ADDENDUM NO. 1 TO PROJECT NO. 44303

HVAC WORK AND ELECTRICAL WORK

**REPLACE ABOVE GROUND HOT WATER PIPING
MARCY CORRECTIONAL FACILITY
OLD RIVER ROAD
MARCY, NY**

March 5, 2013

DWG NO:
S-502.1

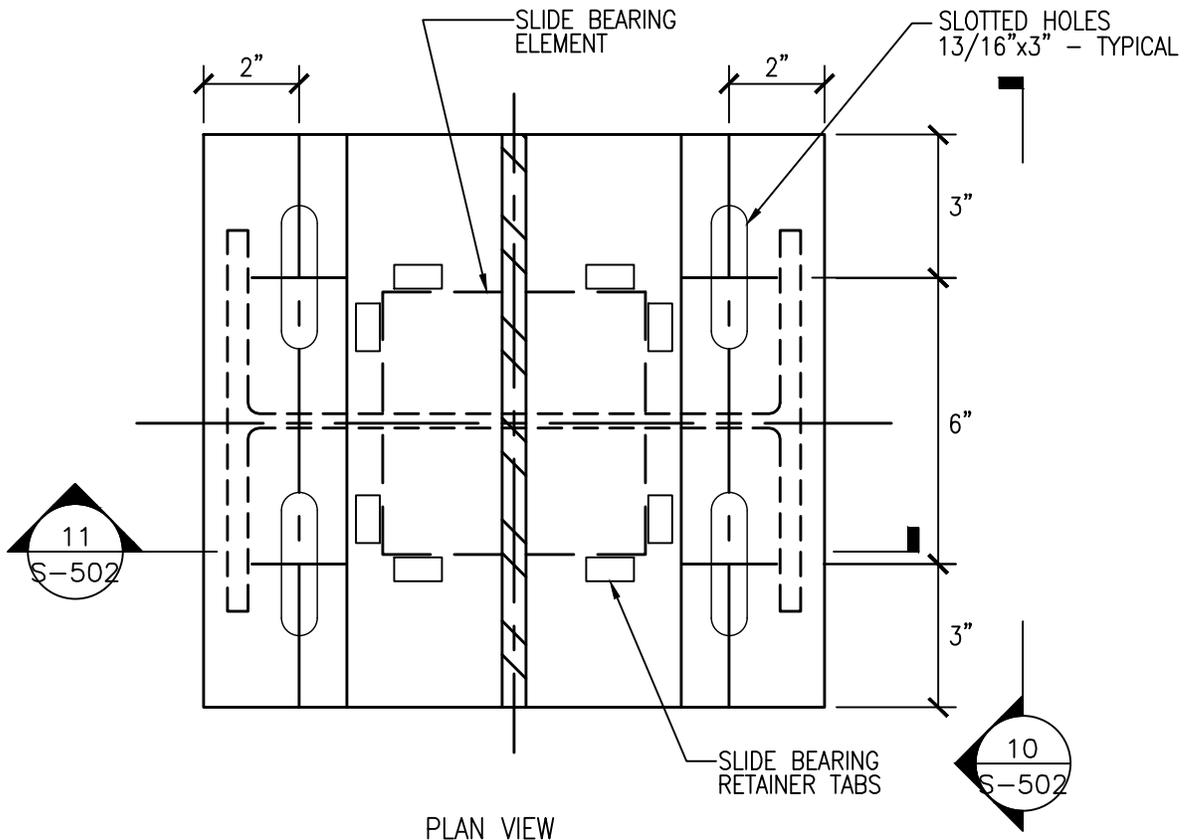
6. Drawing S-502:
 - a. Add Detail 9, dated 3/4/13 on Addendum Sketch S-502.1.
 - b. Add Detail 11, dated 3/4/13 on Addendum Sketch S-502.2.
 - c. Add Detail 10, dated 3/4/13 on Addendum Sketch S-502.3.
 - d. Replace Detail 7 with Revised Detail 7, dated 3/4/13 on Addendum Sketch S-502.4.
 - e. Replace Detail 8 with Revised Detail 8, dated 3/4/13 on Addendum Sketch S-502.5.

DWG NO:
 S-503.1

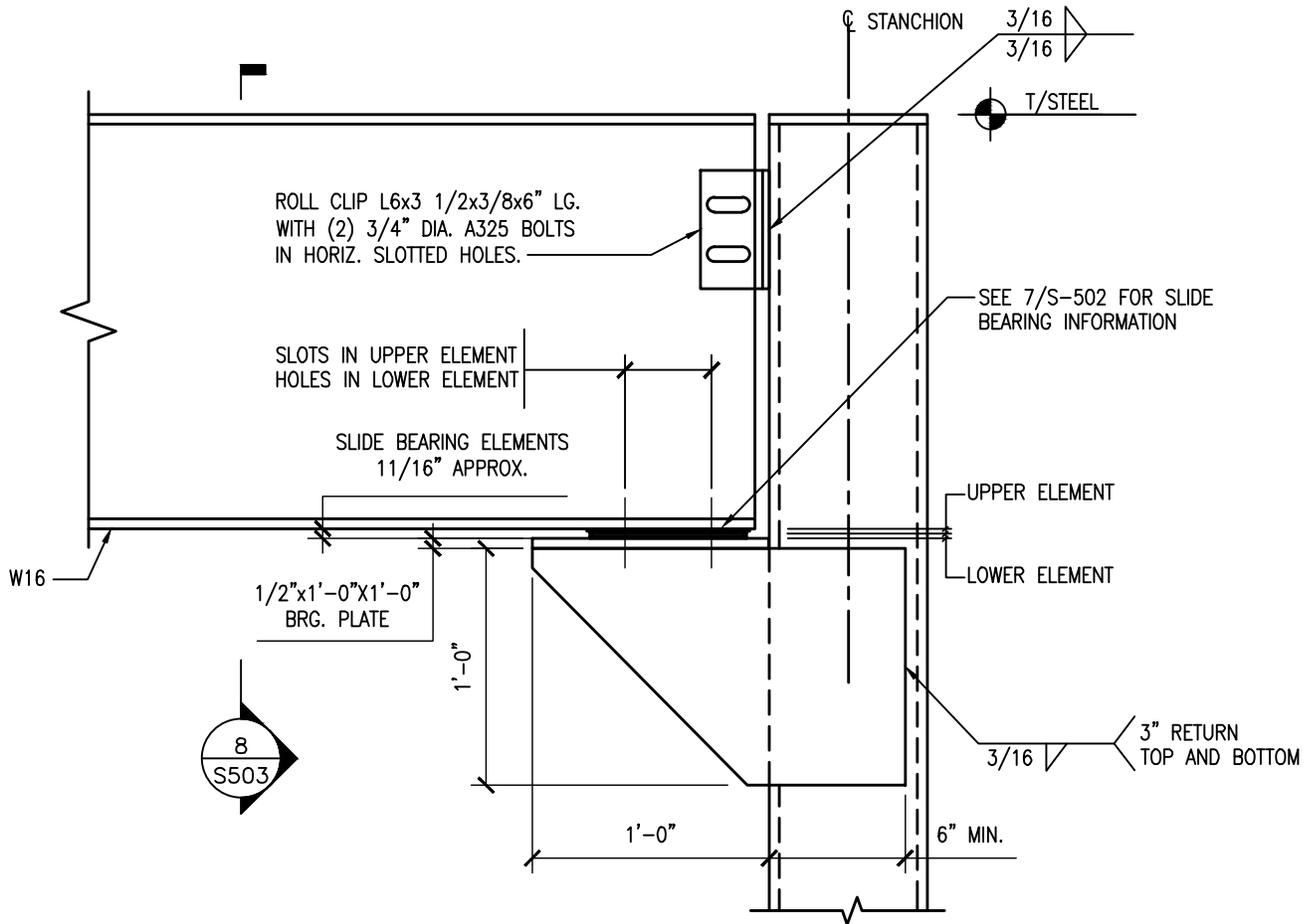
7. Drawing S-503:
 - a. Replace Detail 6 with Revised Detail 6, dated 3/4/13 on Addendum Sketch S-503.1.
 - b. Replace Detail 7 with Revised Detail 7, dated 3/4/13 on Addendum Sketch S-503.2.
 - c. Replace Detail 8 with Revised Detail 8, dated 3/4/13 on Addendum Sketch S-503.3.
